To: T10 Technical Committee
From: Rob Elliott, HP (elliott@hp.com)
Date: 8 November 2004
Subject: 04-339r1 SAS-1.1 Remove minimum ALIGN counts from summary table

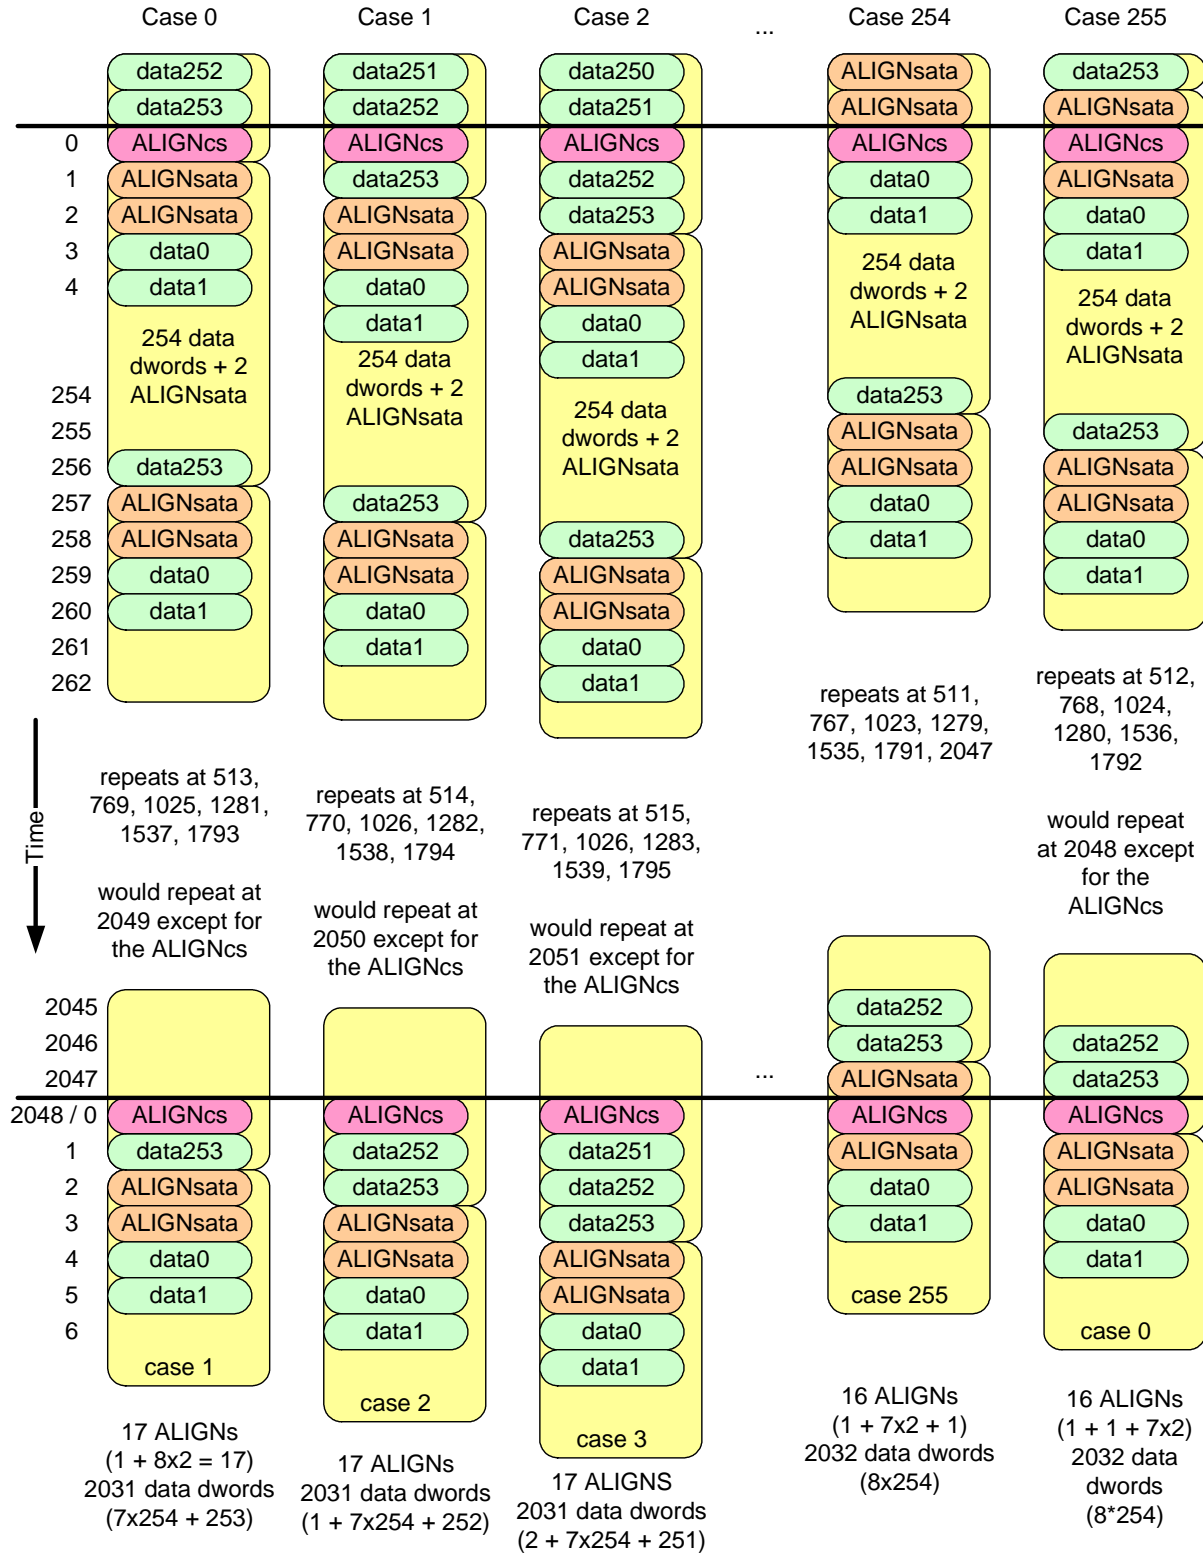
The minimum number of ALIGNs summary column in Annex G provides incorrect numbers for the STP entries.

For example, the "17 ALIGNs per 2048 dwords" calculation for the "STP connection; 1.5 Gbps physical link rate and 1.5 Gbps connection rate" combination is not always correct; as shown in the following figure, the count actually alternates between:

- 1) 17 ALIGNs for 2046 overlapping windows of 2048 dwords; then
- 2) 16 ALIGNs for 2 overlapping windows of 2048 dwords.

The example in the figure assumes that the ALIGNs for SATA are sent together within each 256 dwords, although that is not necessarily the case for STP; no matter when then are sent, the result is the same.

This also affects the STP entries for the 3.0 Gbps physical link rate with both connection rates.

Since the actual numbers are complicated, simply remove the offending column.
